**MEETING NOTICE AND AGENDA**  
**MANSFIELD PLANNING AND ZONING COMMISSION**  
Regular Meeting

**TUESDAY, January 3, 2012 ■ 7:15 PM**

File 1307: Eastbrook Mall (Special Permit Application)

**Memo to:** Planning and Zoning Commission  
**From:** Linda M. Painter, AICP, Director of Planning and Development  
**Date:** December 29, 2011 *[Signature]*  
**Subject:** Freedom Green Cease and Desist Order

View of retaining wall  
from applicant's prop-  
erty

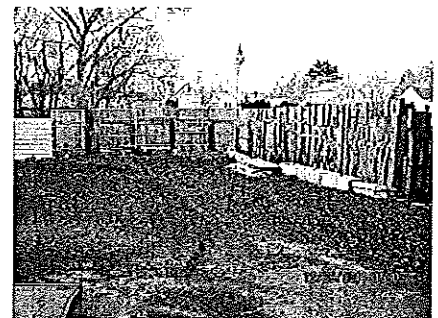
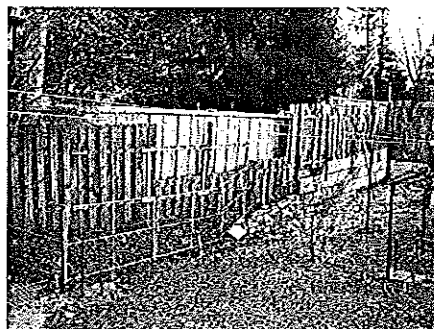
Currently, the fencing installed on top of the concrete block retaining wall is a patchwork of different types and materials. A new solid fence, six to eight feet in height, should be installed to properly screen the area from neighboring properties. The design of such fence should be approved by either the Commission or the Director of Planning and Development to ensure compatibility with adjacent properties.

- Prohibition of expansion of non-conforming use to westernmost portion of property, including specific indicators of expansion such as vehicle storage, etc.
- Replacement of current boundary fence with solid fence of one material/design to be approved by Director of Planning and Development

**Landscaping Plan**

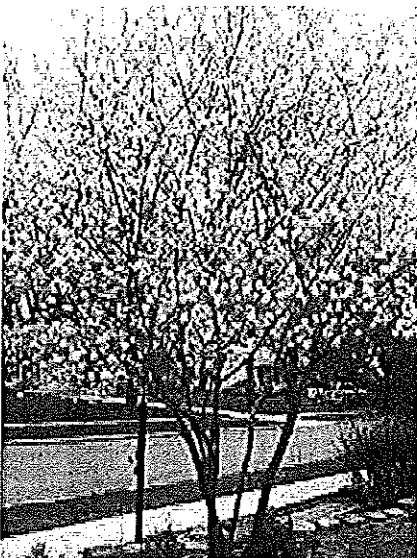
After reviewing the plan, staff suggests that the plantings in the landscape island in the middle of the driveway for building A be changed from 4 Mugo Pines to a Shadblow Tree. Additionally, the Shadblow tree proposed to the south of Building B needs to be labeled.

- THE LANDSCAPE PLAN BE REVISED TO LABEL THE SHADBLOW TREE LOCATED TO THE SOUTH OF BUILDING B; CHANGE THE PROPOSED MUGO PINES IN THE DRIVEWAY LANDSCAPE AREA OF BUILDING A TO A SHADBLOW TREE, AND THAT THE FINAL PLAN BE SIGNED AND SEALED BY REGISTERED LANDSCAPE ARCHITECT THAT PREPARED THE PLAN (PETER MINIUTTI).
- THE GRADING PLAN BE REVISED TO ELIMINATE PROPOSED GRADE CHANGES TO THE FRONT AND SIDES OF STRUCTURES A AND B.
- ANY CHANGES TO THE GRADING PLAN NEEDED TO COMPLY WITH SURFACE DRAINAGE REQUIREMENTS OF THE STATE BUILDING CODE SHALL BE SUBMITTED TO THE ZONING AGENT FOR INCLUSION IN THE PROJECT FILE.

#### Grading Plan

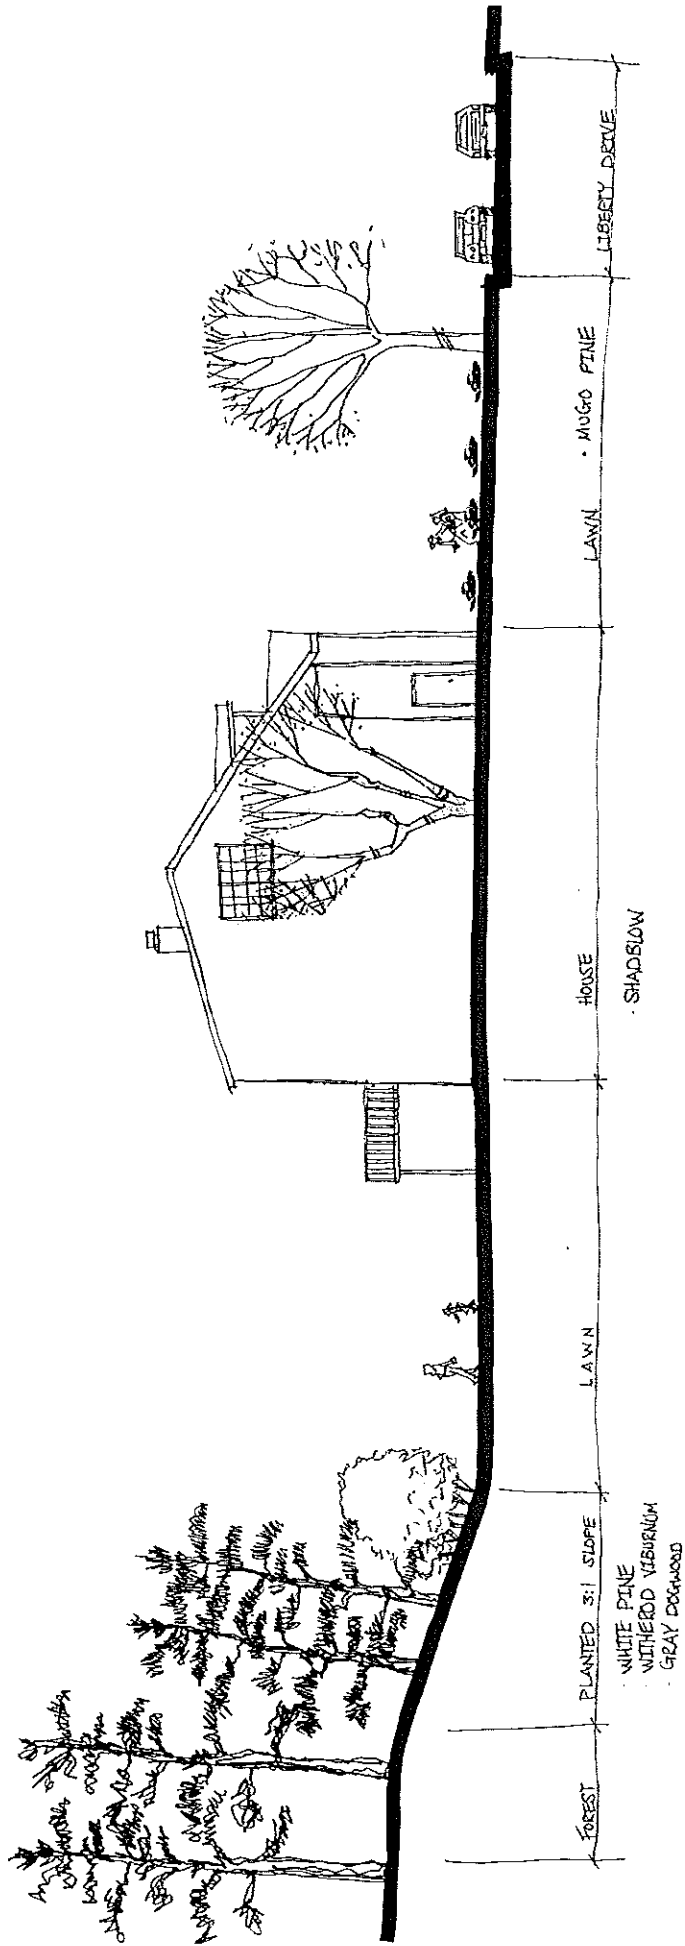
In response to the Commission's motion, the applicant has attempted to reduce the height of the buildings through limited re-grading at the front and sides of the buildings. However, after conferring with the Building Official, it appears that these proposed grade changes would conflict with State Building Code requirements in several locations. For example, the proposed elevation of 262 feet south of Building A would place the final elevation higher than the Finished Floor Elevation of 261.9 feet. A minimum of 6" pitch away is required within 10 feet of the building. Additionally, any wood structural members within 6 inches of soil must be decay resistant. Footing drains for habitable areas may also be necessary. The Building Official typically inspects for these types of drainage issues as the building is being constructed, however, in this case, such issues would not have been identified during the initial construction process as the changes are only now being proposed.

Given the range of Building Code issues that could be triggered by these proposed changes and the limited impact those changes would have on the apparent height of the buildings, staff recommends that no changes to the grading to the front and sides of the buildings be made. While there appear to still be a couple of drainage issues that the applicant will need to address, particularly between Buildings A and B (potential need for a drainage swale leading to the rear of the buildings), the proposed re-grading appears to create more problems for long term surface drainage around the structures than it would solve. Additionally, after further review the Zoning Agent has determined that Building A does conform to the maximum height allowed of 40 feet; as such, grading is not needed to address what was originally thought to be a 9 inch violation of the maximum height requirement.

The grade changes proposed the rear of the buildings, adjacent to the emergency access drive are appropriate and should be made to soften the slope. The builder is encouraged to meet with the Assistant Building Official to review the existing grades identified on this plan to identify any changes to building or surface drainage that may be required to comply with Building Code requirements.
